INVITATION FOR BIDS: CCK-2689-23

IMPROVE SANDERS-BROWN CENTER ON AGING/NEUROSCIENCE FACILITIES

PROJECT #2571.0

ADDENDUM # 4

1 REF: 1/A-7.1b - ROOF PLAN
AD-A-4.4 1/4" = 1'-0"

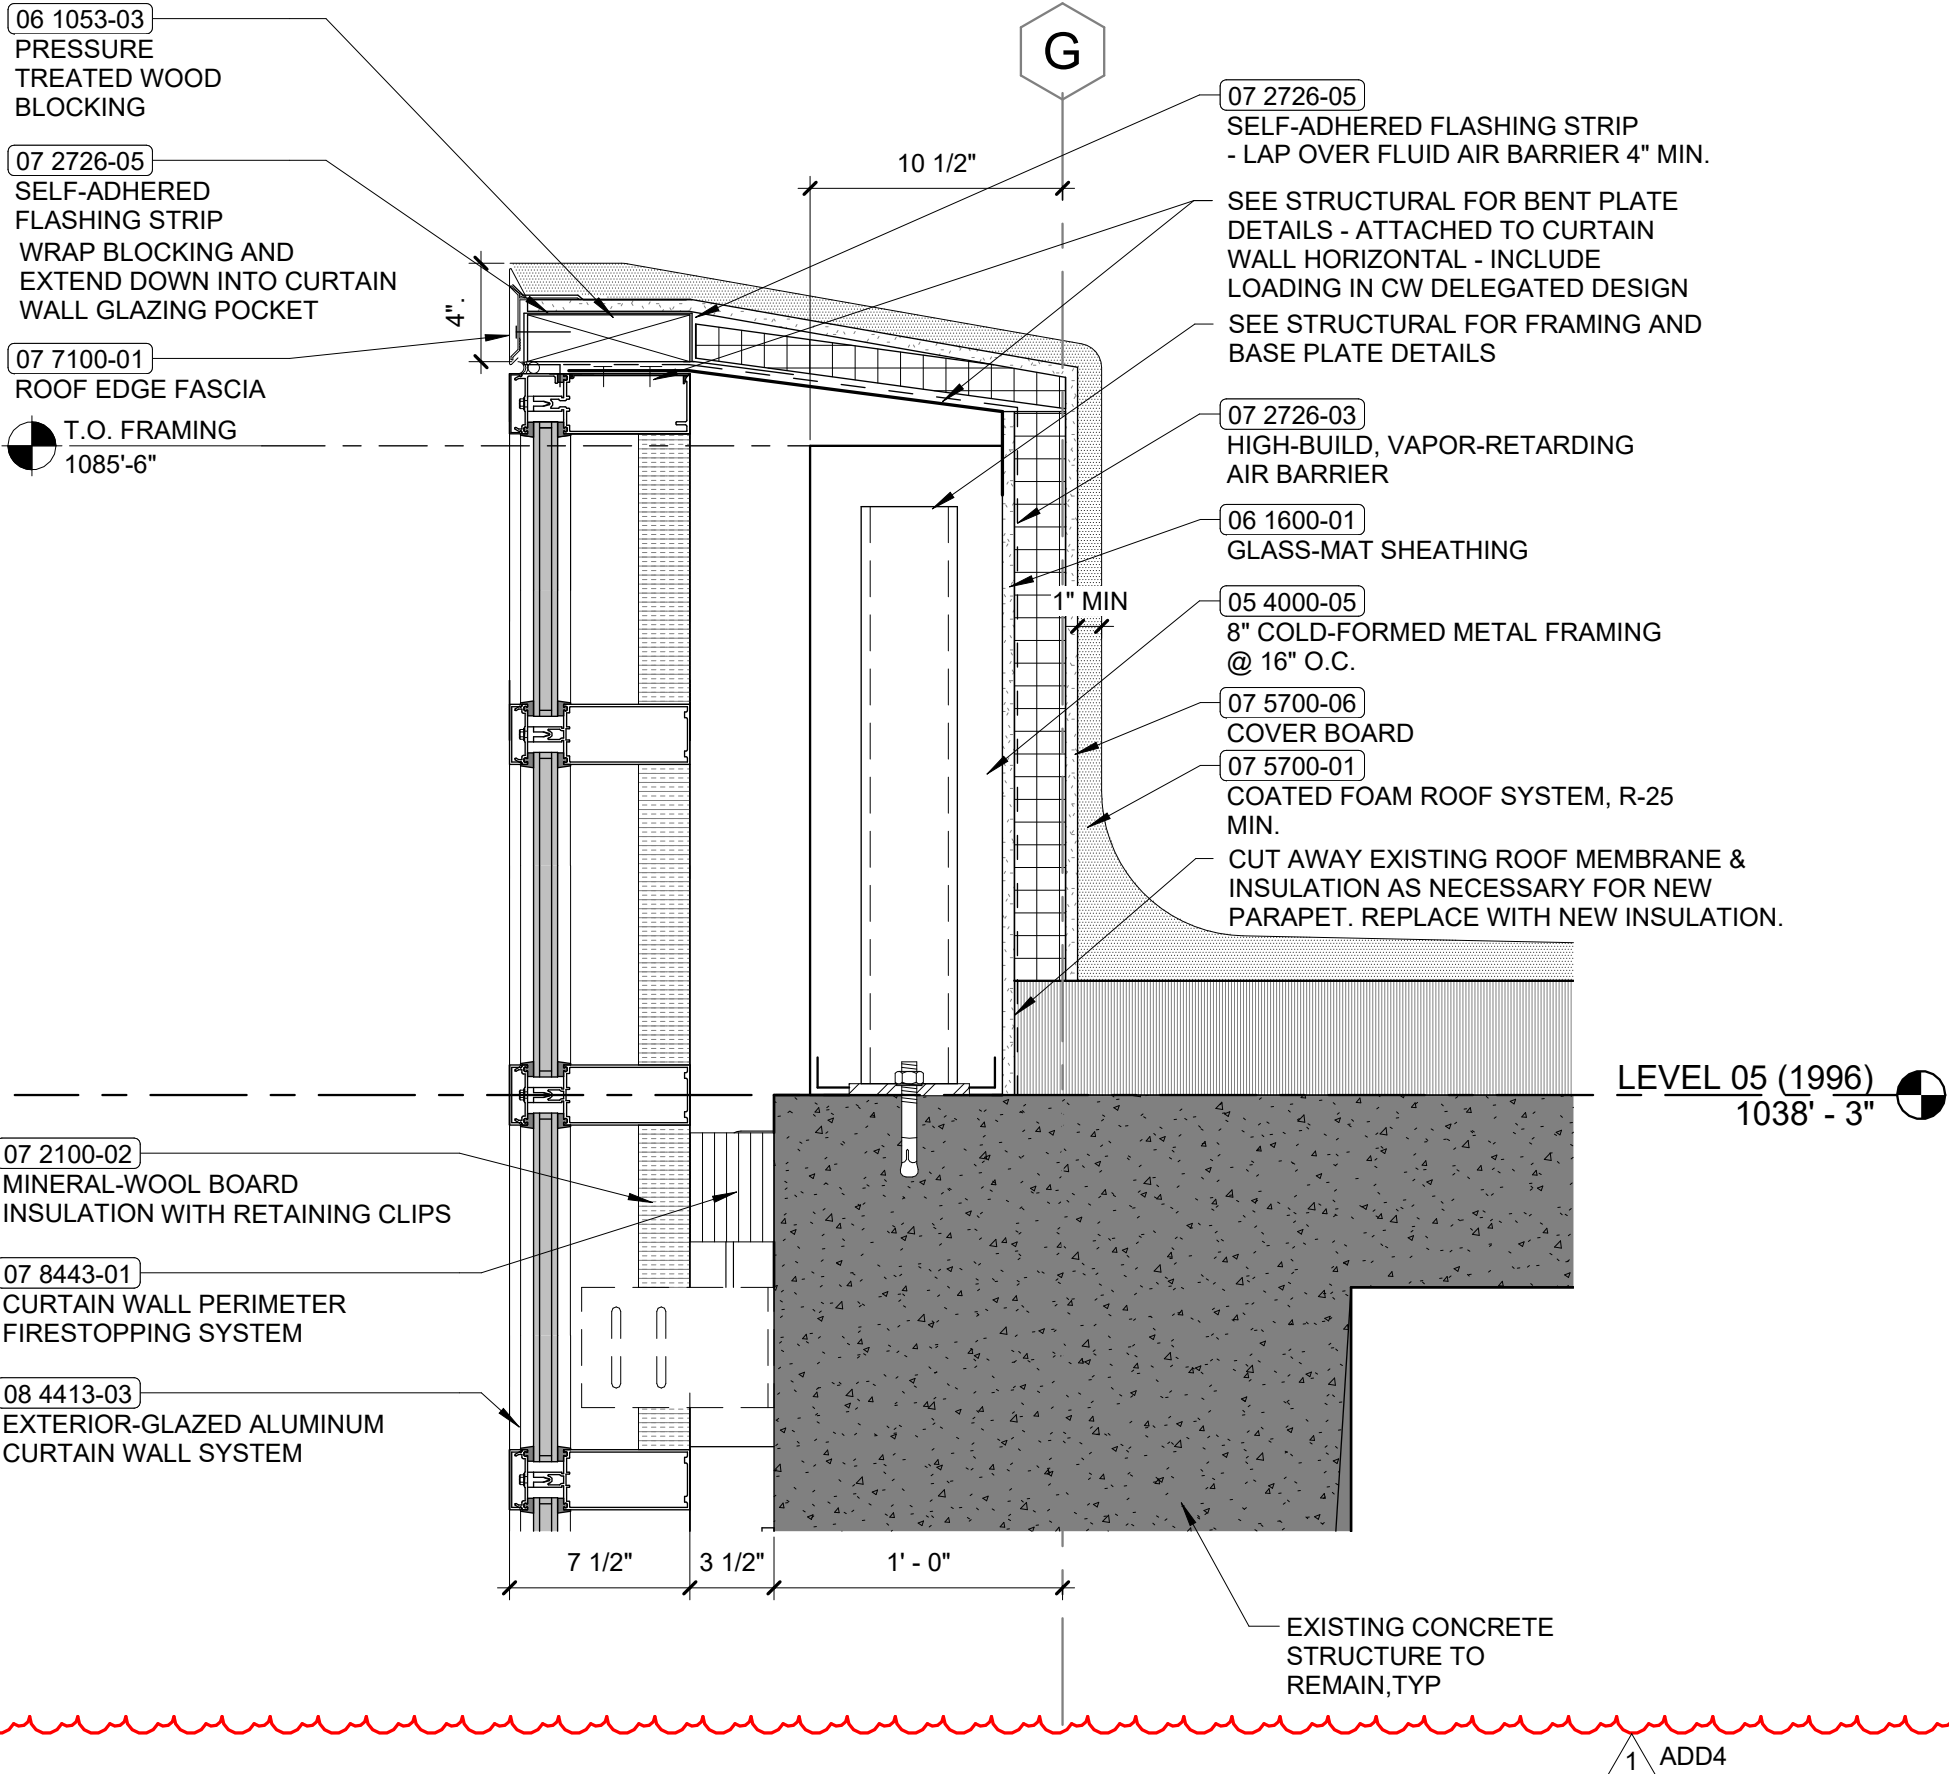
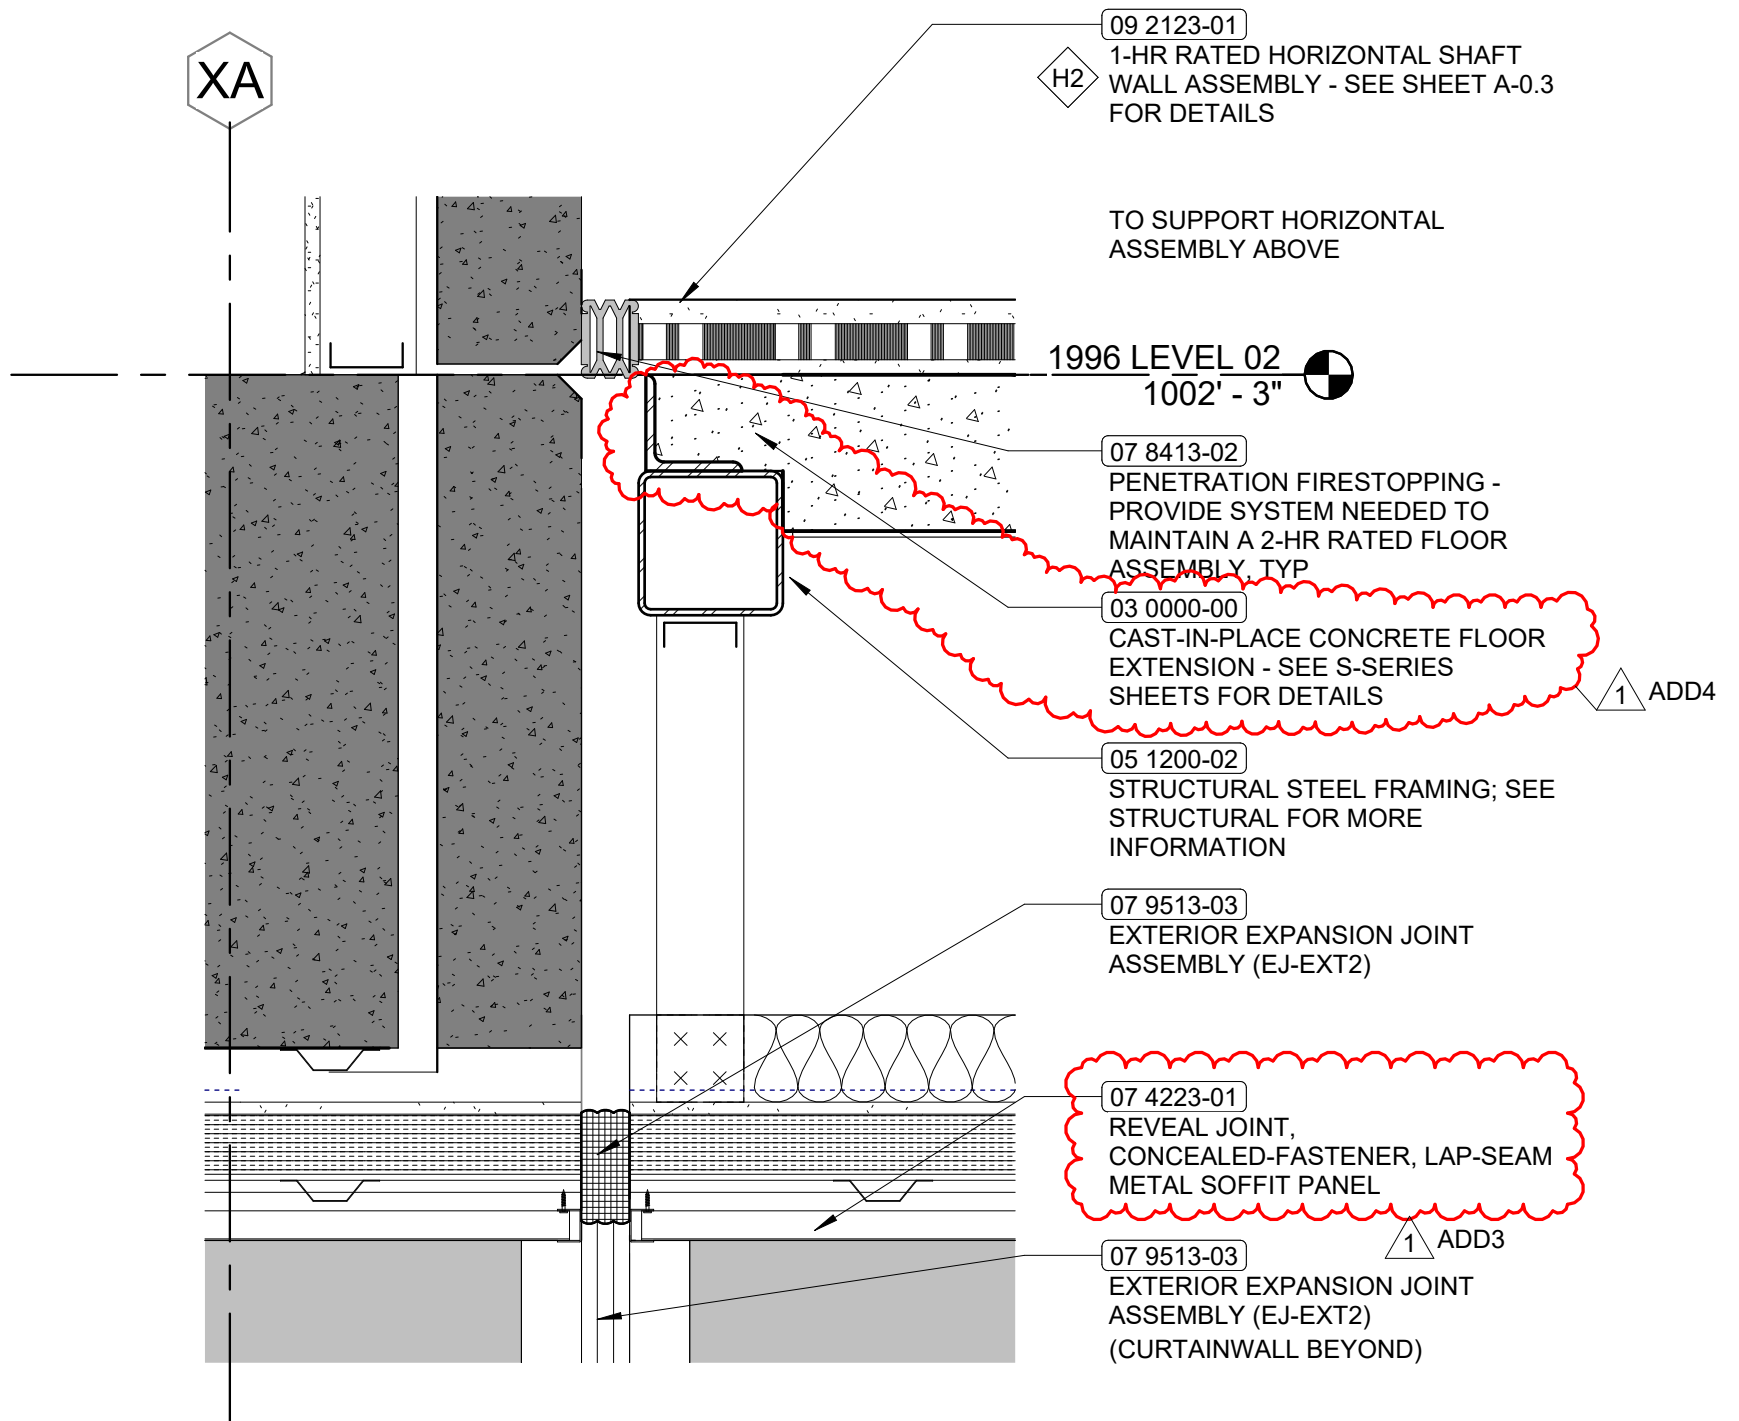
52. **Drawing A-7.2** – Question: “Detail 3/A7.2 depicts the parapet framing as overhanging the existing concrete by 3.5”. Detail P/S4.1 depicts the parapet framing inset an unknown/arbitrary dimension away from the existing concrete edge. Placement of the framing affects concrete anchor layout among other things. Please clarify

Answer: Match Structural Detail P/S4.1. Embed anchors in channel plate base shall be located minimum 4" from edge of concrete beam. Channel center line and CFS wall centerline shall match. Refer to attached drawing AD-A-4.5.
